# Direct Wire #190

**Subject: Power Supply Design Change**

**Products: LYNX Touch 5210 and 7000**

**March 2016**

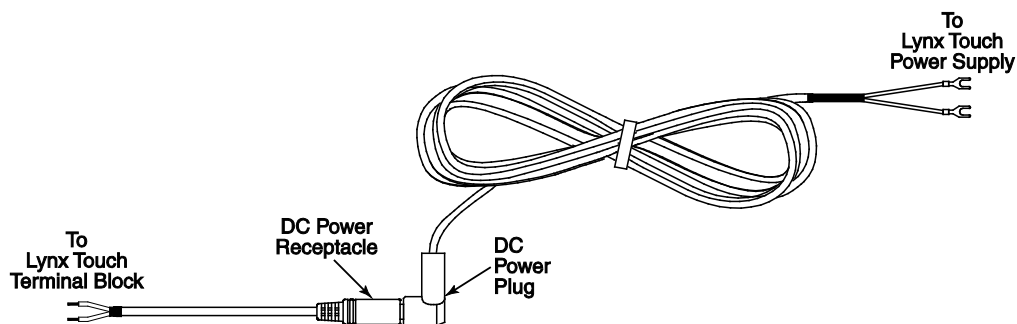
Honeywell has made a design change to the LYNX Touch 5210 and 7000 home and business control systems that removed the built-in barrel-type power supply connector from the circuit board. In order to continue to provide a quick-disconnect capability, a new power connector adapter has been added to the LT-Cable kit. Additionally, as a result of customer feedback, the color of the accessory cable has been changed to white. The new accessories are more appropriate for these systems and aesthetically pleasing for your customers. The LT-Cable kit now consists of a power supply cable and adapter.

The LT-Cable is now an 8-foot long, white power supply cable, which is better suited for desk-mounting. The adapter is a shorter (pigtail) DC cable that connects to the LYNX Touch terminal block. The opposite end of the DC cable adapter is equipped with a receptacle that connects to the plug on the power supply cable.

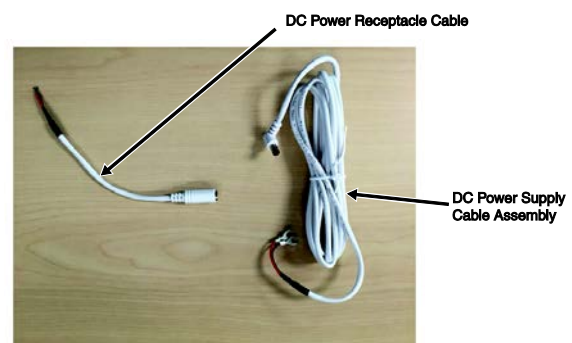
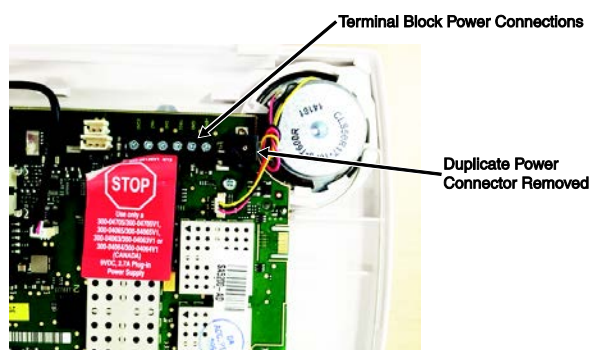
Additional benefits of the LT-Cable kit include a simple power connection that end users can control, along with the option to use the LT-Cable on Lyric controllers\* and other power cord applications. To follow, please find images of the connections and cables for further clarification.
